**GEOLOGIC FEATURES AND THEIR
POTENTIAL EFFECTS ON CONTAMINANT
MIGRATION, SANTA SUSANA FIELD
LABORATORY**

Howard G. Wilshire, Ph.D.

October 5, 2006

My review of the Rocketdyne consultant's reports reveals that the preponderance of evidence in those reports contradicts the conclusion that most of the faults and fine-grained units are aquitards. A big weakness in the Rocketdyne consultants' hypothesis is the inferior quality and quantity of field-derived information about the physical character of these features. Both the fault zones and fine-grained rocks are more susceptible to erosion than the coarser-grained sandstones that crop out prominently on the SSFL, and so are not as well exposed. But the descriptions of existing outcrops and other exposures, as well as the data in numerous well logs, directly contradict claims that the faults and fine-grained units are barriers to groundwater migration.

Exhibit 1. Drawdown contours (in feet) from water extraction, 1954-1997 in the northeastern part of the SSFL. From L. P. Smith (Haley & Aldrich), Appendix B, Conceptual Site Model, Santa Susana Field Laboratory, Hydrogeology Summary Report (April 2000), Figure 1.9.

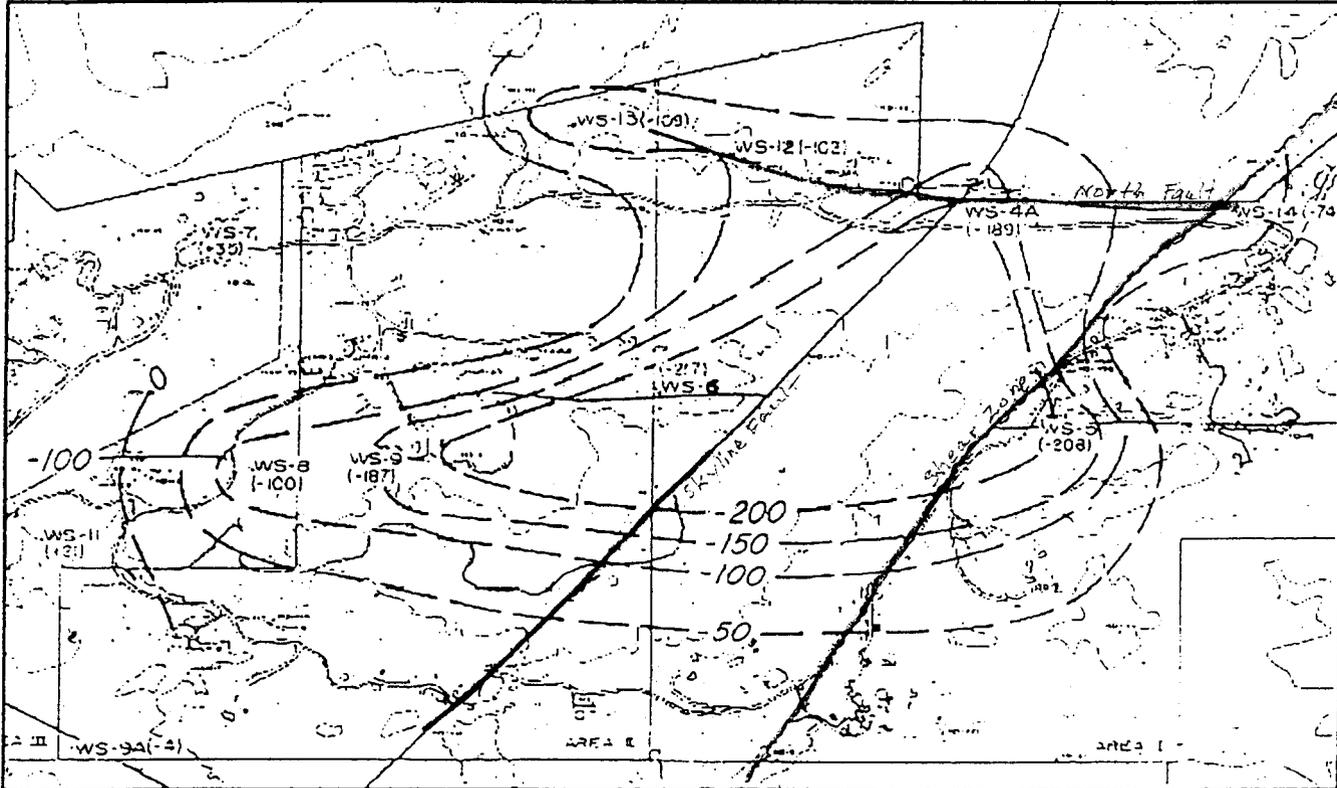
from the fault is not clear. Rates of response through the different kinds of fracture systems (clusters of steep fractures in the fault zone) and discontinuous, complex joint and stress fracture systems may cloud pump testing results. This is consistent with the behavior of wells WS-4A, WS-12, and WS-14 in the 1996 hydraulic communications study.⁷⁶ These wells did not respond immediately to shutdown of WS-6, but water levels in those wells (see Exhibit 3 for well locations) began to rise five to seven days later. This was true also of WS-13, but it could have been responding to RD-9 as well as WS-6. The drawdown pattern shown in Exhibit 1 also supports North Fault as a groundwater conduit.

Exhibit 2. Hydrographs, 1994-2001, for wells WS-5, RD-45A, RD-45B, and RD-45C. From MWH, Technical Memorandum, Geologic Characterization of the Eastern Portion of the Santa Susana Field Laboratory (February 2002), Figure 15. Note faults differ from current representations.

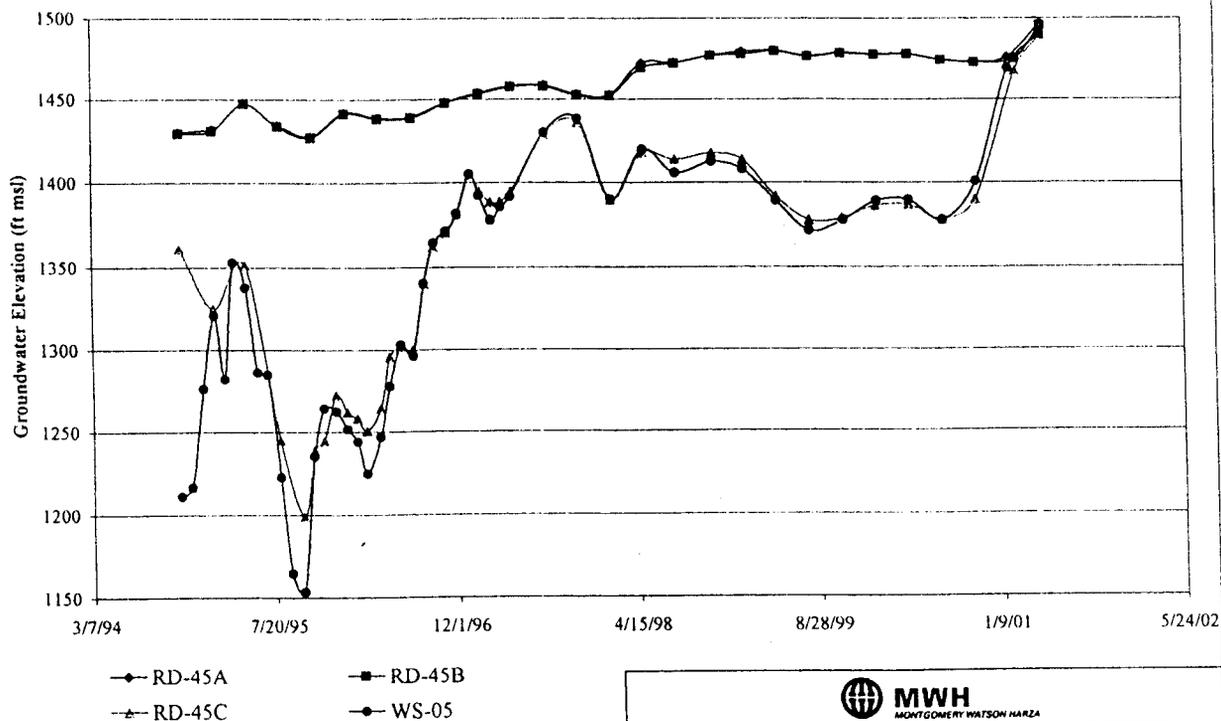
The RD-45 well cluster, now considered to be on the west side of the Shear Zone, shows an interesting response between 1994 and 2001 to shutdown and startup of pumping of well WS-5, on the east side of the Shear Zone. RD-45A is interpreted to be open from the Middle Sage Member across the Lower Line Bed into the Lower Sage Member, RD-45B is interpreted to be open only in the Lower Sage Member, and RD-45C is interpreted to be open within and below the Woolsey Member(?).⁶⁵ It should be noted that lithologic logs of these wells indicate that the Lower Line Bed is allowable in 45A and C, but not in B, and that identification of the Woolsey Member(?) is not allowable by the lithologic log of 45C, that is, the material logged at the appropriate depth in 45C does not resemble descriptions of the Woolsey Member. Other reports⁶⁶ identify this level of 45C as the Happy Valley Member, which also does not resemble the well log. Exhibit 2 shows the long-term hydrographs for wells WS-5 and the RD-45 cluster. RD-45C practically duplicates the water level pattern of WS-5, whereas RD-45A and B do not respond to shutdown or pumping of WS-5. It is noteworthy that shutdown of WS-5 in October

2000 resulted in a makeup of the 80 foot difference in water levels between RD-45A, B and RD-45C. Table 4 of the 1997 Hydraulic Communications report shows all three wells of the RD-45 cluster responding rapidly to well shutdown and restart, but hydrographs show that RD-45A and B are responding to well WS-6, whereas RD-45C is responding to well WS-5. This behavior is perplexing, but it is difficult to see how, at least at the screen level of RD-45C, the Shear Zone can be acting as an aquitard.

West of the Shear Zone, wells C3, RD-45A, and RD-45B are located within the Lower Sage Member, stratigraphically above the Woolsey Canyon Member. A section between 585 and 655 feet depth in RD-45C is tentatively interpreted to represent the Woolsey Canyon Member (note that this earlier was interpreted to represent the Happy Valley Member, but the log of RD-45C for that interval does not resemble descriptions of either the Woolsey Canyon or Happy Valley Members; identification of the Lower Sage Member in C3, RD-45A, and 45B also has difficulties because of uncertain location of the Lower Line Bed—see discussion of Shear Zone). The water level in RD-45C, thought to be open below the top of the Woolsey Canyon Member was at the time of the measurements about 80 feet lower than that of wells C3, RD-45A, and RD-45B.¹⁰⁴ As previously discussed, this difference was made up with the shutdown of WS-5 in 2000 (Exhibit 2).

Exhibit 3. Portion of SSFL, showing locations of wells WS-5, RD-73, RD-38A, B, and WS-14, and current locations of faults. From MWH, Near-Surface Groundwater Characterization Report, Santa Susana Field Laboratory (November 2003), Figure 2-9.

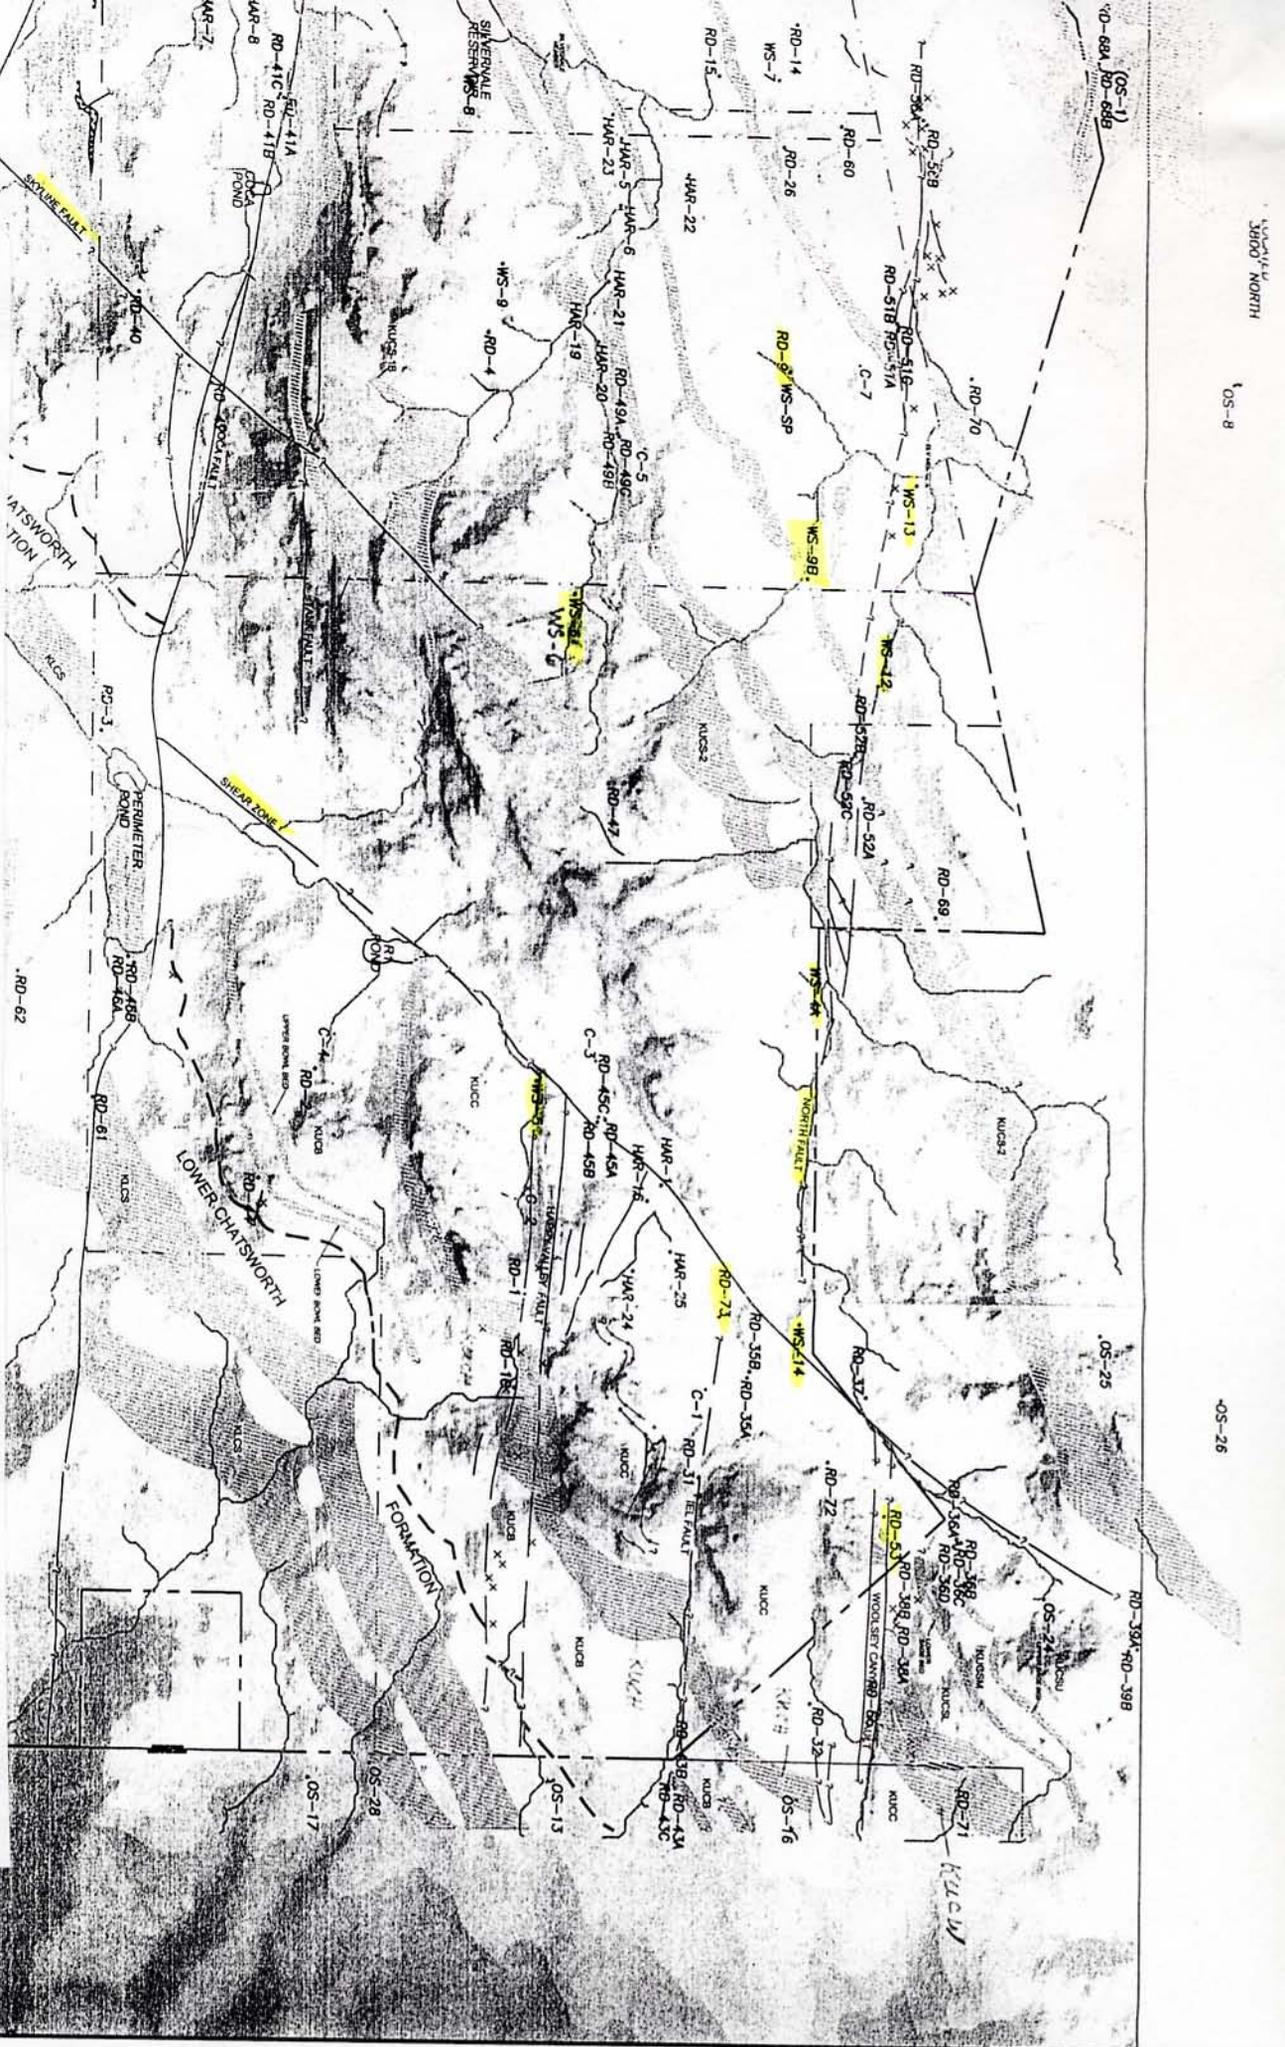
The lack of response of WS-14 to a 90-day pump test of RD-73, located on opposite sides of the Shear Zone is further taken as evidence that the Shear Zone is an aquitard.⁶⁷ This may well be the case, but until WS-14 is precisely located with respect to the full extent of the Shear Zone and RD-73 is precisely located with respect to the IEL Fault, this will remain uncertain. That conditions in the vicinity of WS-14 are complex is shown by the RD-38 cluster, which is closer to WS-14 than is RD-73. RD-38A did not respond to a pump test of the adjacent RD-38B (see Exhibit 3). This unexpected result is explained by the presence of a hypothetical gouge zone, which was not observed on video logs, between the two wells.⁶⁸ To compound the uncertainties, the log of RD-53, located in the Woolsey Canyon Fault Zone that separates RD-73 and the RD-38 cluster, does not mention any fault-related features.⁶⁹

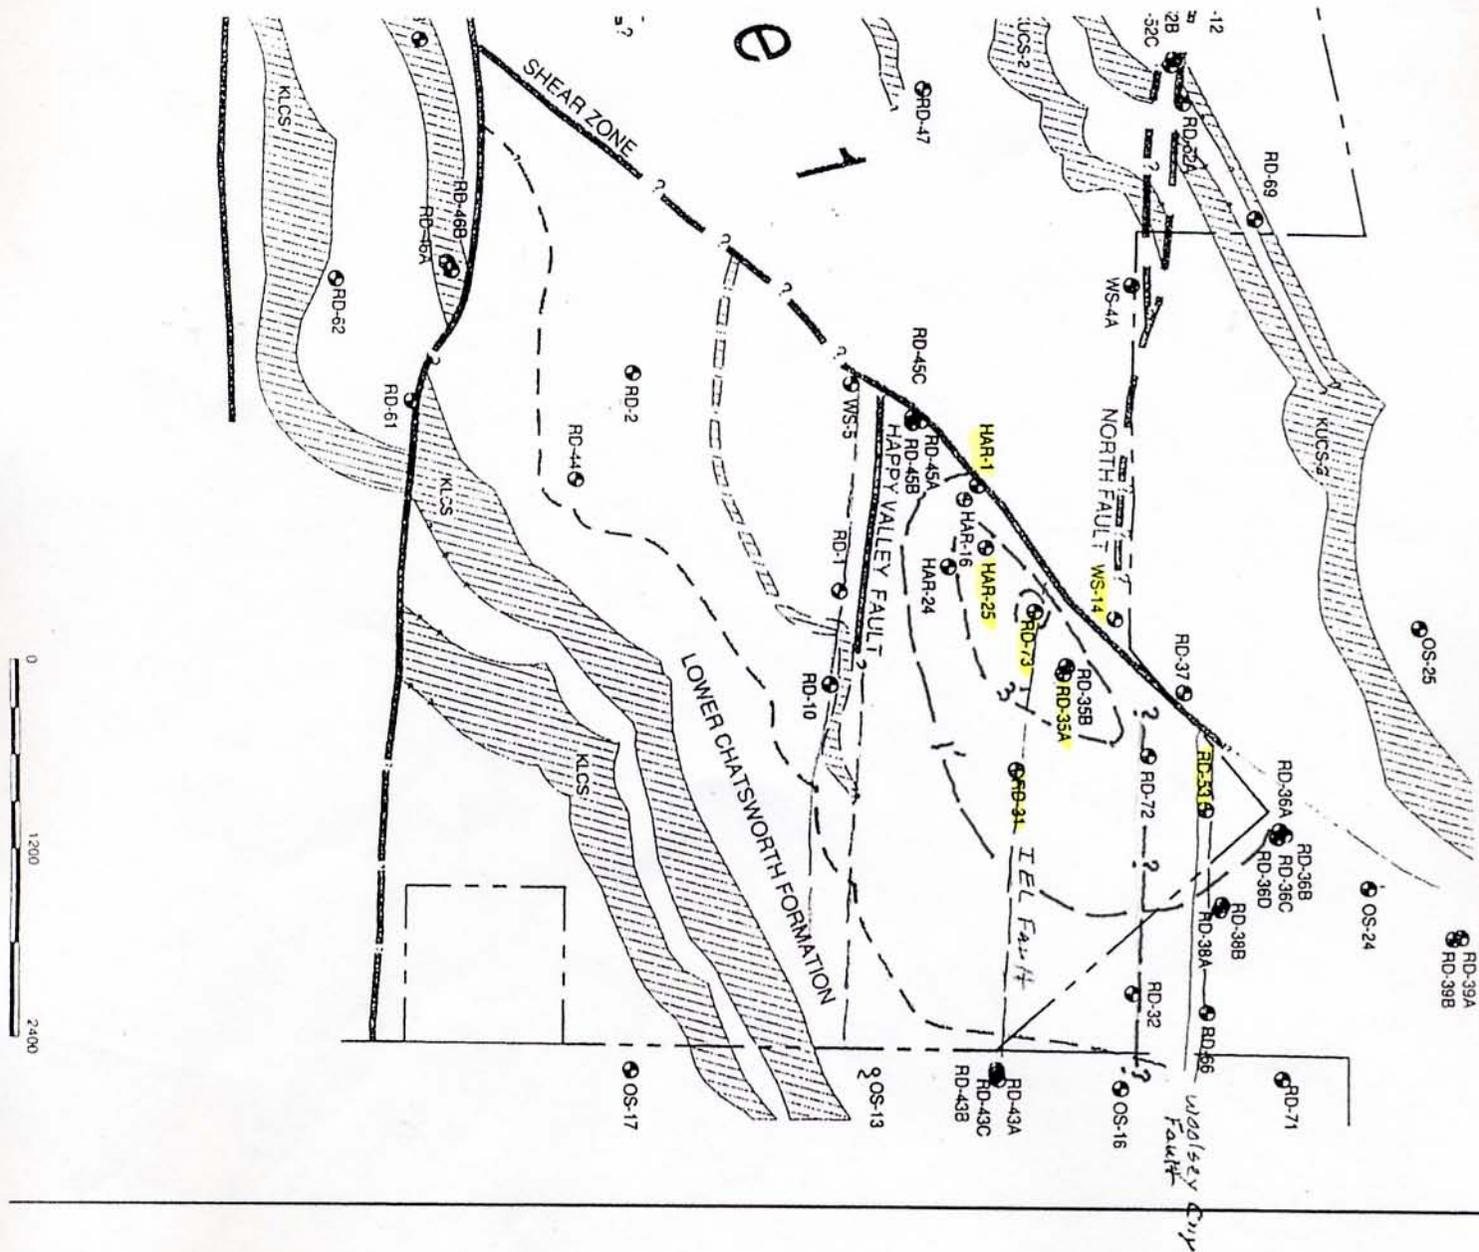
Contours representing drawdown from the RD-73 pump test are shown in Exhibit 4. The contours are interpreted to indicate an apparent rise in hydraulic conductivity about parallel to strike of the Chatsworth Formation, and that "drawdown appears to truncate at the shear zone to the west, and at the Happy Valley Fault to the south."⁷⁰ This is based solely on the behavior of WS-14 (discussed in the previous paragraph) because no other wells west of the Shear Zone were monitored, and there is no control for designating the relationship of drawdown to the Happy Valley Fault. Representation of the contours as crossing the subsequently recognized IEL and Woolsey Canyon Faults without deflection does not prove that they are not aquitards, but rather there is no control for the location of the contours—that has not changed since the contours were drawn or the faults were mapped. A possible E-W fault passes very close to RD-72 and RD-32 between the Woolsey Canyon and IEL faults.⁷¹ The presence of a fault in this area is supported by the video log of RD-32,⁷² which logs a number of broken zones; a log of RD-72 is not yet available.

72. Among the problems with this interpretation is the lack of information of where RD-72 may be located with respect to a possible fault in close proximity to RD-72 (see Exhibit 4). In addition, RD-72 has a history of sporadic TCE detects, at times showing no contamination.⁸⁰ As shown in Exhibit 4, drawdown contours for a pump test of RD-73, and in Exhibit 5, water level contours for Groundwater Unit 1a as recognized in 2000, the contours pay no attention to faults, including the Woolsey Canyon Fault Zone, the IEL Fault, and the possible fault near RE-72, not recognized at that time. However, no new data that would discredit the interpretations represented by the contours have been made available subsequently. Thus, the role of the Woolsey Canyon Fault Zone as an aquitard is putative.

Representations of drawdown contours from a pump test of RD-73 (Exhibit 4) and of water levels in Groundwater Unit 1a (Exhibit 5) do not show any effect of the then-unrecognized IEL Fault, but no new data have been provided to show the contours to be wrong.

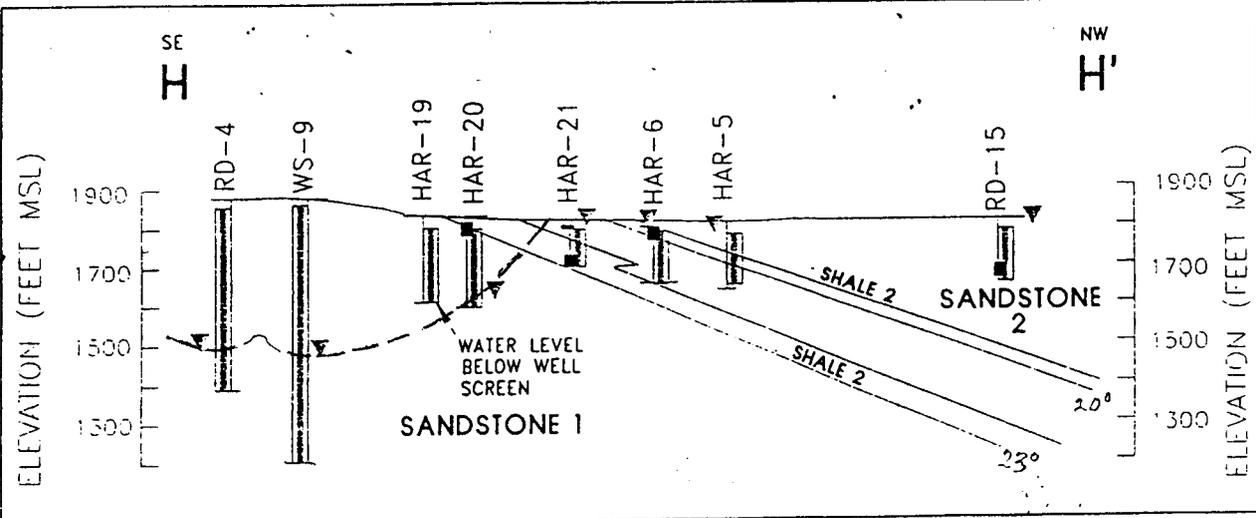
Exhibit 6 illustrates the case that Shale-2 acts as an aquitard between Sandstones-1 and -2 (old designations), as seen in water levels in wells RD-4, WS-9, HAR-19, and HAR-20 screened in Sandstone-1, and HAR-21, HAR-6, HAR-5, and RD-15 screened in Sandstone-2. Wells RD-4 and WS-9 are pumped wells with water levels governed by long-term extraction. Wells screened in Sandstone-2 are about 200 to 300 feet higher than those screened in Sandstone-1. It should be noted that the section in Exhibit 6 is viewed toward the south, contrary to normal practice.⁹⁵ The section does not position HAR-20 and HAR-21 consistently with the rather complex representation of Shale-2 in Fig. 2-9 of the Near-Surface Groundwater study. In addition, the well distribution is a shotgun pattern, but no information is given on how the wells were projected to the section line. It also is not clear why other wells in the area were not used to assess the water level differences—wells not used that might represent Sandstone-1 conditions include RD-49A, RD-49B, RD-49C, and C-5, and those that might represent Sandstone-2 conditions, but which were not used, include HAR-22, HAR-23, and RD-16.

An unassessed alternative to the interpretation that Shale-2 in this particular area is acting as an aquitard is shown by the dashed line drawn in on the section line of Exhibit 6. This is meant to indicate the possibility that the water levels in HAR-19 and HAR-20 are on the side of a drawdown cone produced by pumping of RD-4 and WS-9. The drawdown cone could intersect

the ground surface east of the wells screened in Sandstone-2 and thus not have affected their water levels.

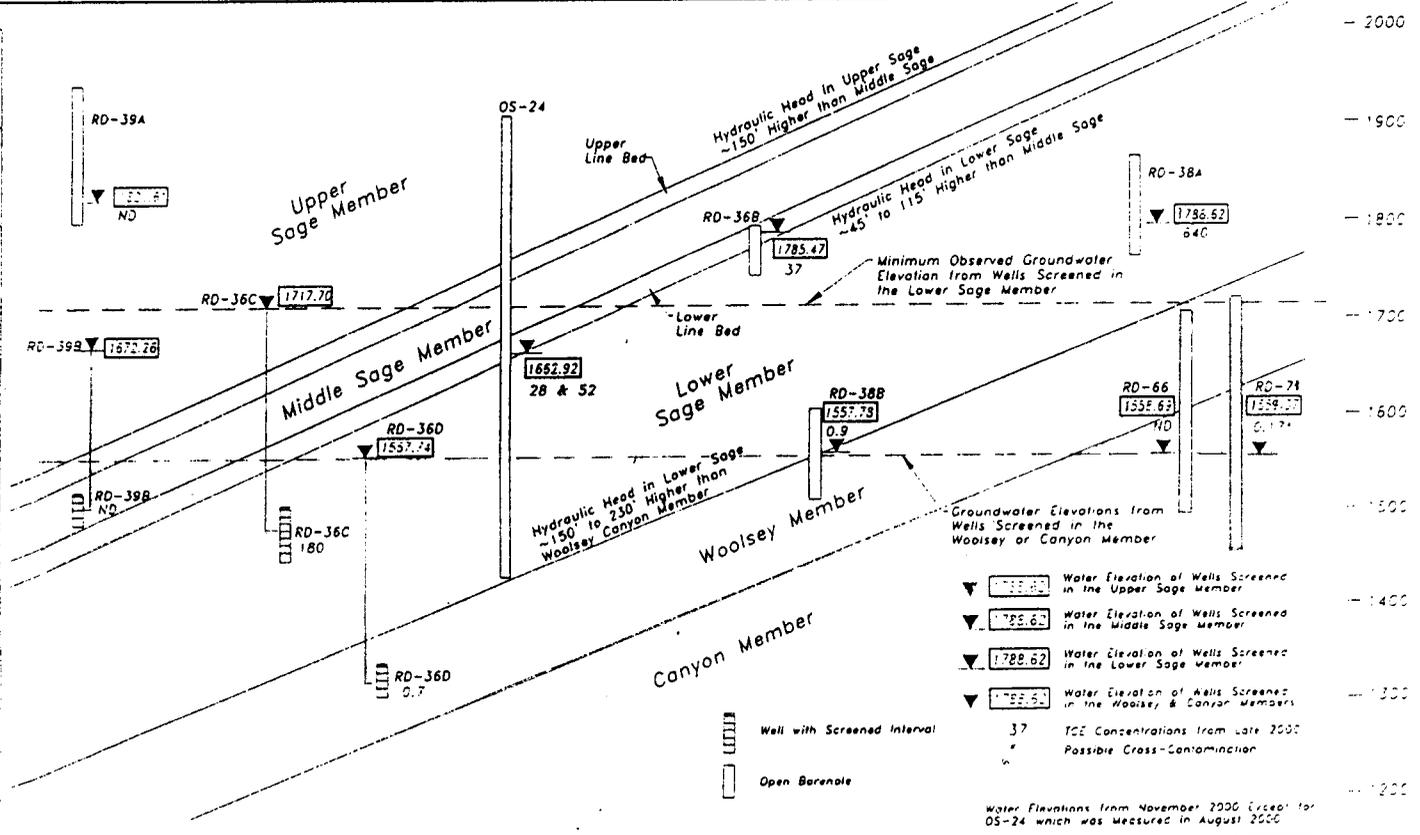
Support for the Upper Line Bed being an aquitard is found in the 150 foot difference in hydraulic head of RD-39A and RD-39B. RD-39A is screened solely in the Upper Sage Member and RD-39B solely in the Middle Sage Member. The Upper and Middle Sage Members are separated by the Upper Line Bed. A pump test of RD-39B did not affect the water level in RD-

39A, lending further support to the Upper Line Bed being an aquitard.¹⁰⁰ Since RD-39A is the only well screened solely in the Upper Sage, this provides only a very skimpy basis for assessing the broader role of the Upper Line Bed; moreover, there are only two wells, one periodically dry, screened solely in the Middle Sage (RD-39B and RD-36A). Because of the proximity of RD-39A and B to the Shear Zone, more confirmatory evidence is needed to assess the role of the Upper Line Bed. The pump test may or may not be significant, considering the similar behavior of RD-38A and RD-38B and the lack of tangible evidence of separation by an aquitard (described in connection with the Woolsey Canyon Fault Zone above), and the behavior of the Lower Line Bed described below.
